# **A G E N D A**

## **Architectural Review Board**

**February 28, 2017**

# ROOF PLAN

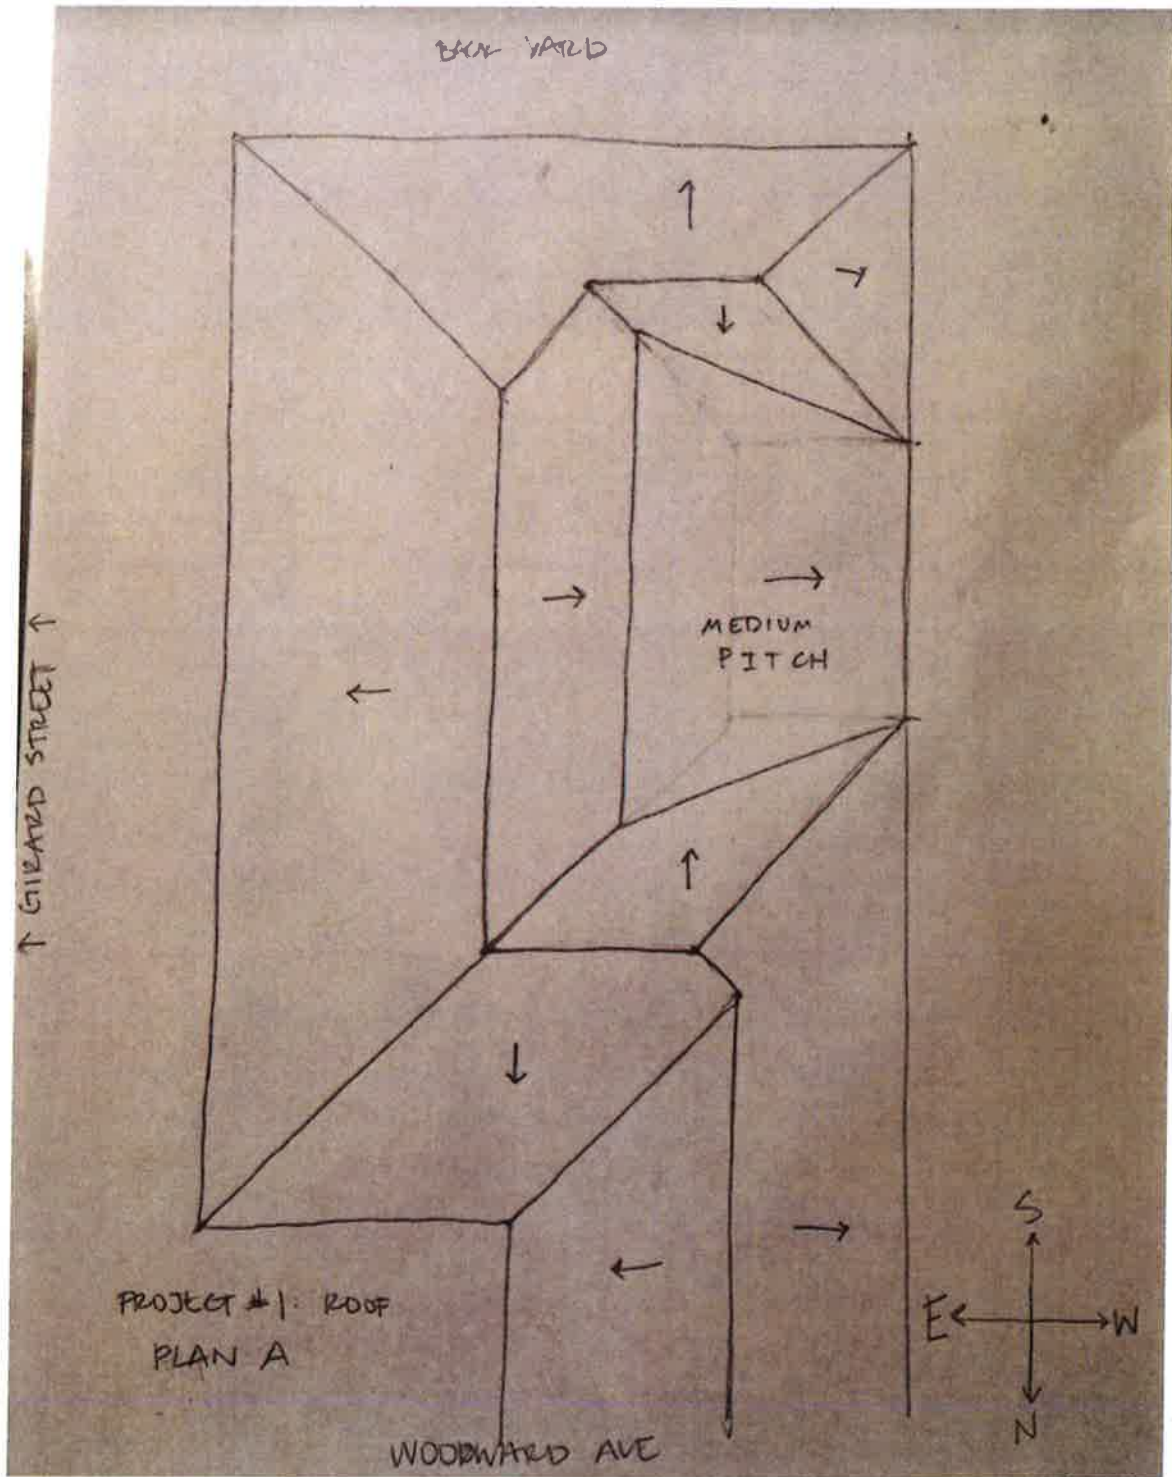
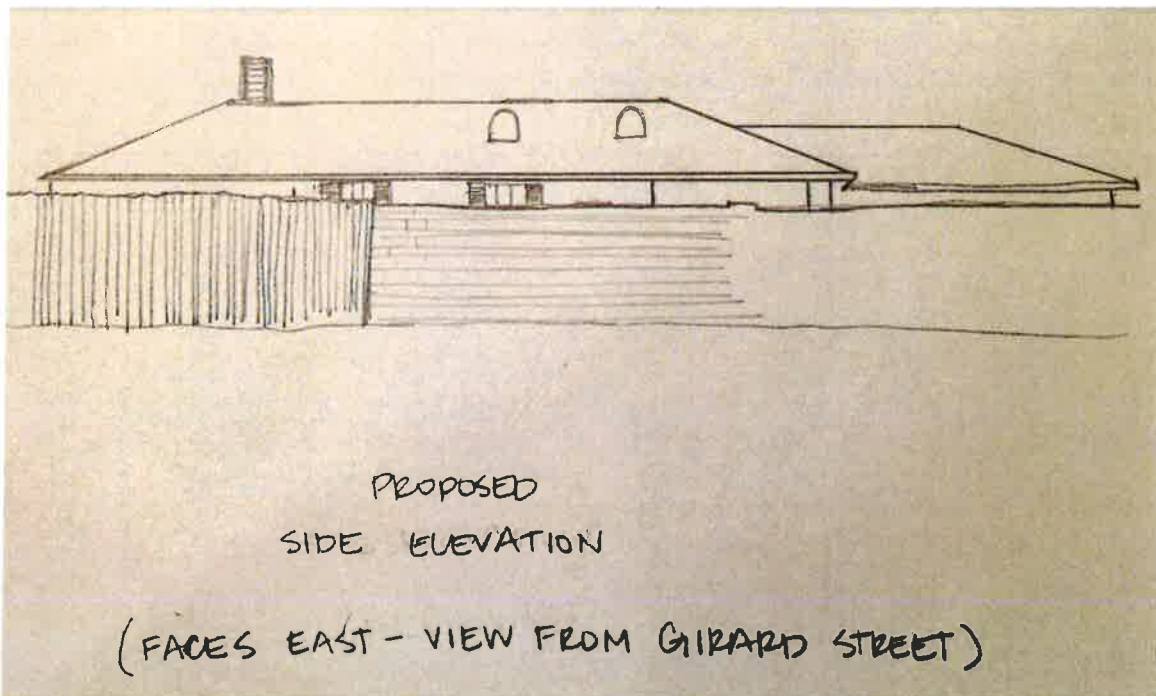
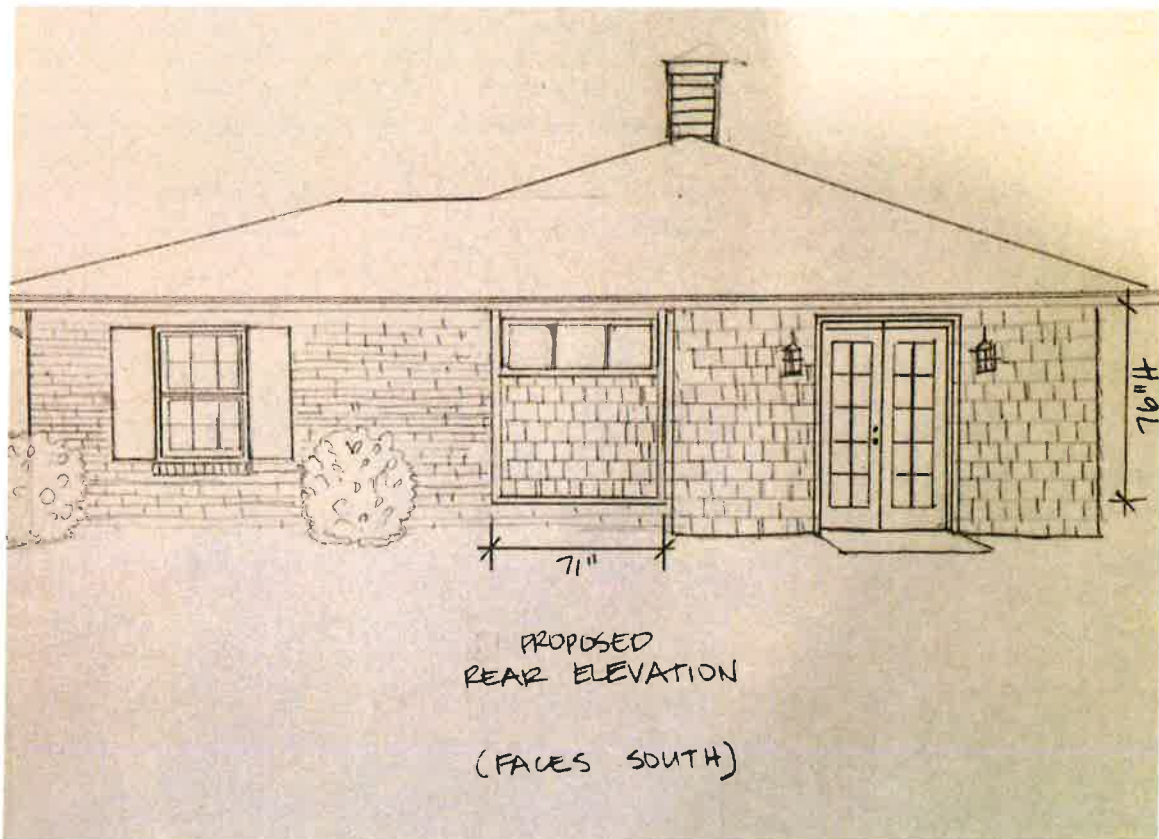
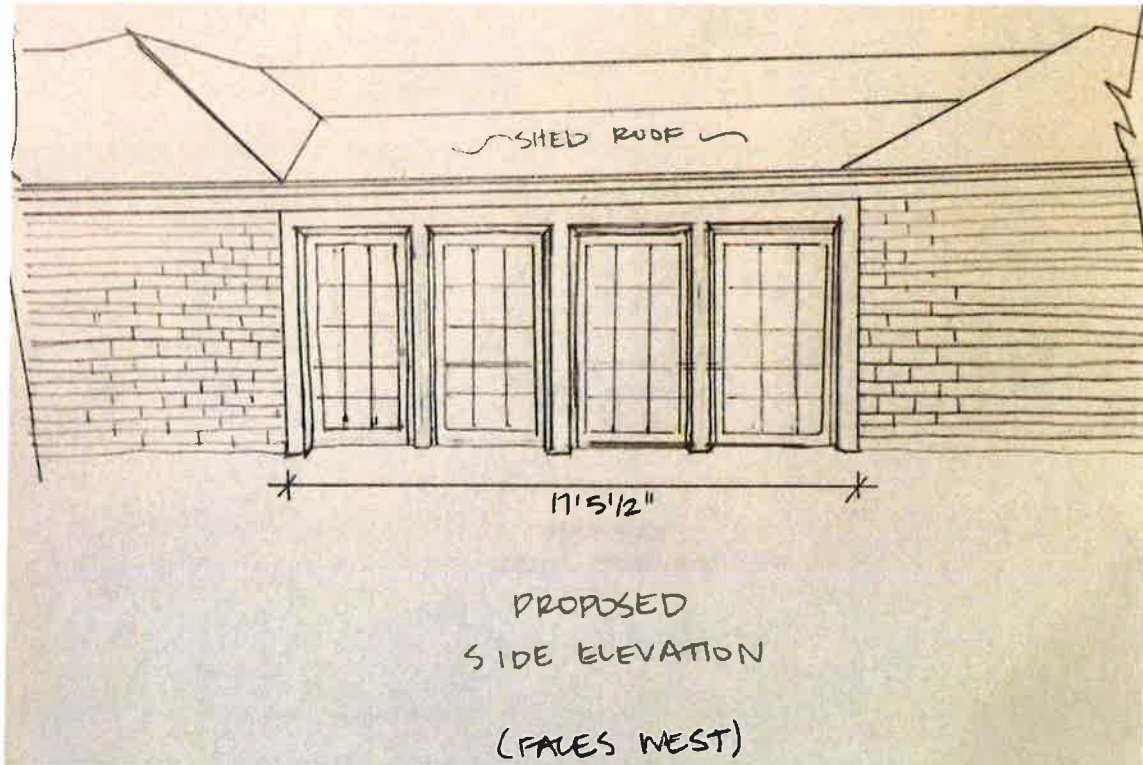
- Add a pitch to two flat roofed sections of the house with drainage issues. There are two proposals: the first is to extend on ridge over one of the flat roofs, and the other flat roof would tie in with a shed roof as illustrated; the second proposal would add just enough pitch to each roof that water will shed. In both cases, a dark gray/neutral architectural shingle is proposed.

- Replace a large plate glass window in the south wall of the house (rear) in the master bathroom. The replacement is a smaller true divided light salvage window to be installed as a clerestory, and the remaining opening will be filled with paintable siding and wood shingles to match the area to the right of the window.

- Install wooden louvered shutters to the double hung window on the rear of the house to the left of the bathroom window. Shutters will be painted black to match the existing.

- Replace sliding aluminum glass doors with a series of fixed and operable wood French doors as illustrated. This is under the west facing flat roof.
- Install a 6' wood privacy fence on the west property line from the SW corner of the property to just north of the SW corner of the house and return to enclose the rear yard.

- The Board has routinely approved rear yard privacy fences.
- While this house is a newer structure (circa 1965), none of the changes are obtrusive or introduce materials or elements that the Board would take issue with on a historic building. Many of the proposed changes address alterations and additions that were likely made to the house after its construction.

EXTERIOR ELEVATION - 100 DEXTER AVENUE  
SCALE 1/4" = 1'-0"

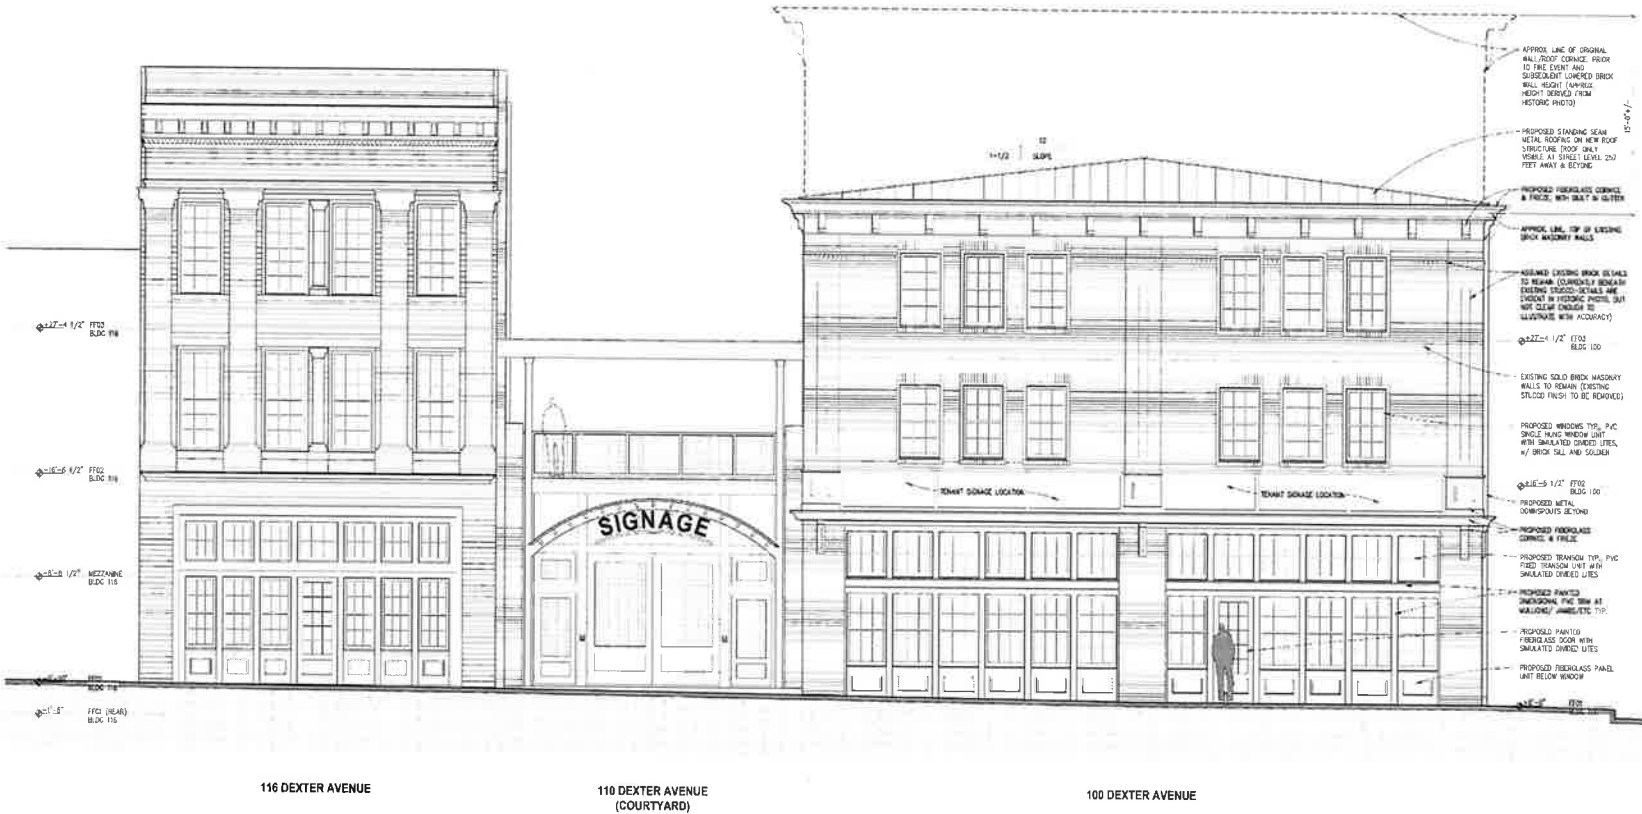
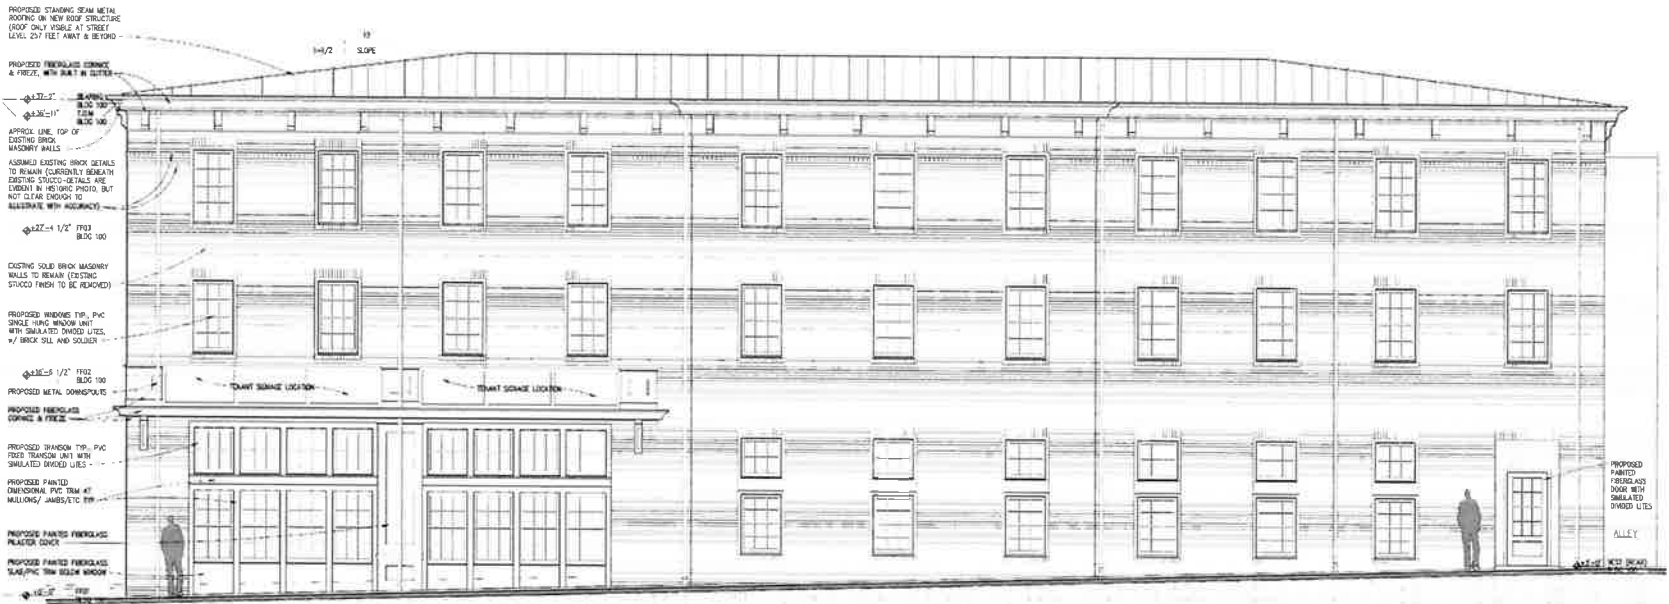
- Remove the non-original stucco from the street elevations;
- Reintroduce a storefront (Dexter & Perry elevations) and other first floor openings (Perry) using fiberglass panels, simulated divided lite (SDL) fiberglass doors and 6:6 windows, dimensional PVC trim and 6 lite transom with SDL, fiberglass cornice and frieze between the 1<sup>st</sup> & 2<sup>nd</sup> floors, proposed fiberglass pilaster cover (Perry St) as illustrated;

- Re-introduce window openings on the 2<sup>nd</sup> and 3<sup>rd</sup> floors using brick sills and soldier course. The building used to be 3 stories before a fire, the additional two stories will be accommodated in the existing space;

- PVC single hung SDL 6:6 windows proposed throughout, fiberglass cornice and frieze with built in gutter at roofline, metal downspouts;
- 1 1/2 in 12 standing seam metal roof installed on new structure behind parapet, visible at street level at 257' away and beyond. See Winter Building for reference.

- Caution is always advised when trying to remove material from brick. Several test sections have indicated that the stucco is not strongly adhered to the brick, but the Board may want to consider recommendations in the event damage to the brick face becomes apparent in the removal process. The gentlest means possible are always recommended when removing a surface coating, and any repointing should be done with a mortar that is appropriate to the age and softness of the brick.
- Will the A. Nachman in the floor of the old entrance be retained?
- The building is missing all of its storefronts and upper story windows, so there is no historic material beyond the brick on the exterior to be preserved. Any decorative elements at the windows or cornice were likely removed or damaged when the stucco was applied.
- No manufacturer for the PVC windows has been provided.

344 Montgomery Street

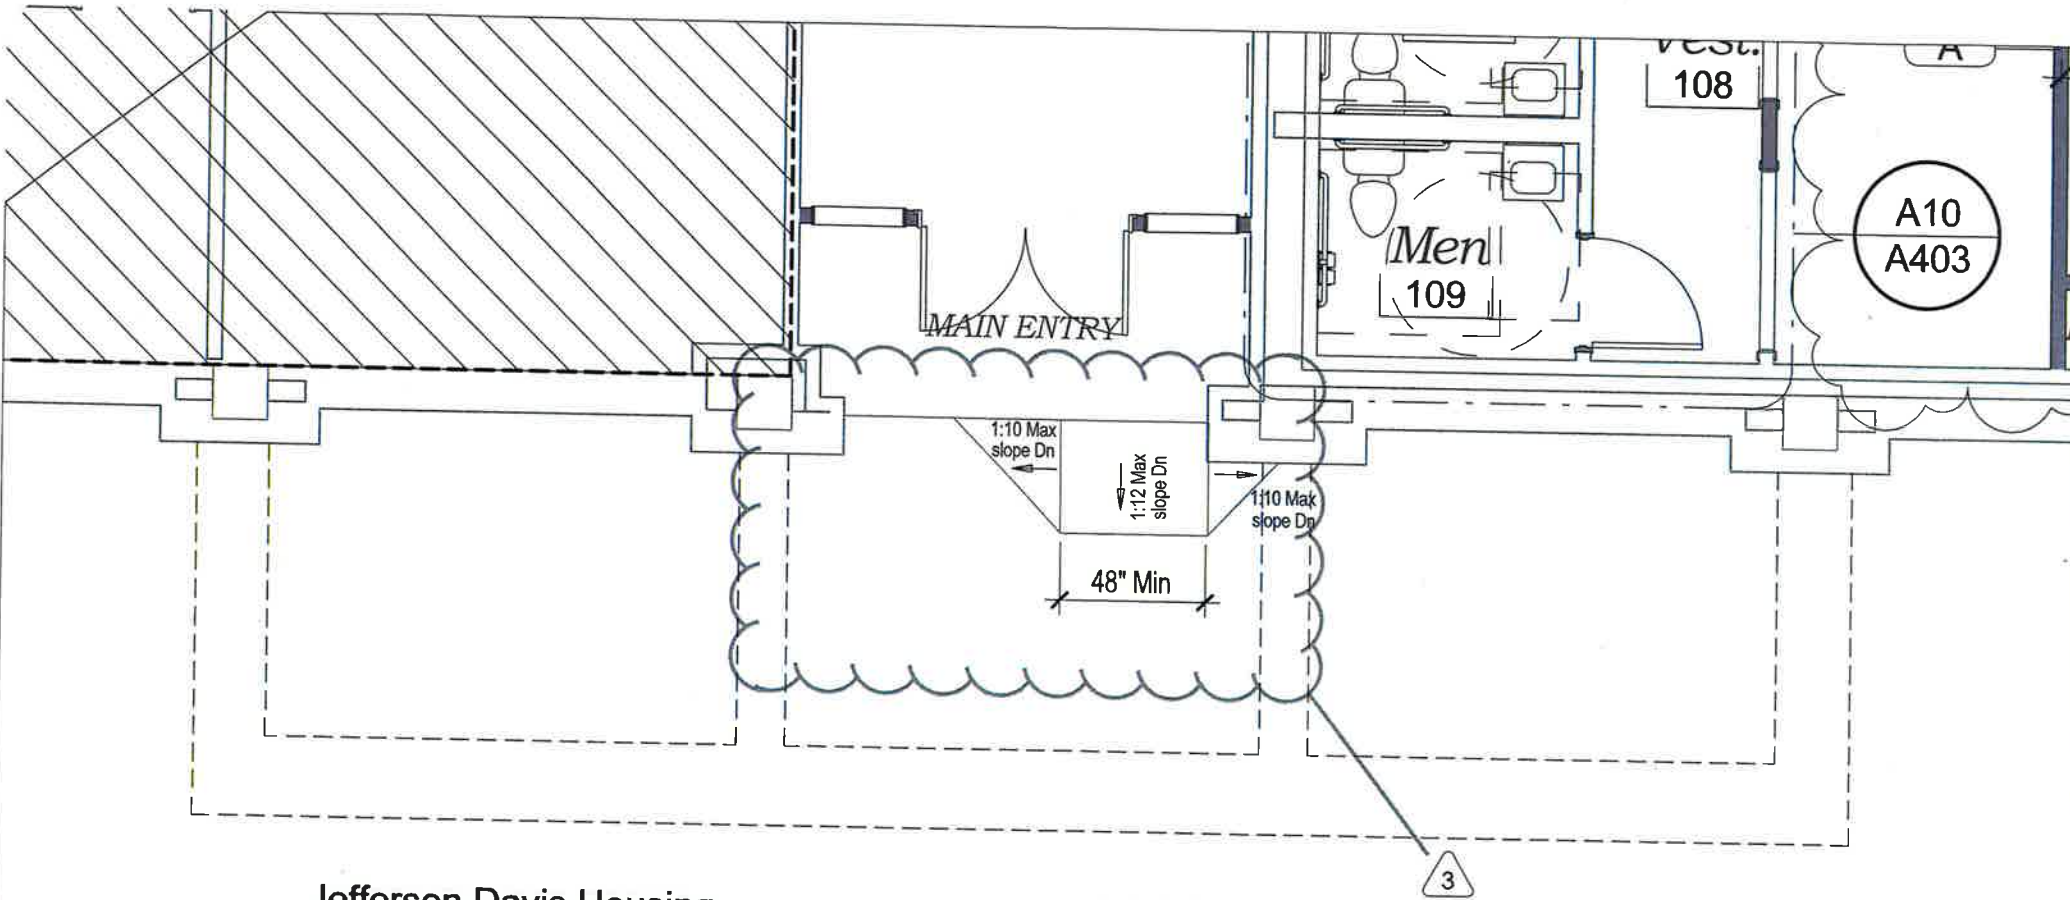
**REMARKS:** The petitioner is requesting permission to construct a concrete ADA accessible handicap ramp to access the front (Montgomery Street) entrance to the building to replace a small, extant metal ramp. The ramp will extend 4' into the right-of-way (license agreement also required from the City) for a 4' wide ramp extending to the right of the door.

- No comment.
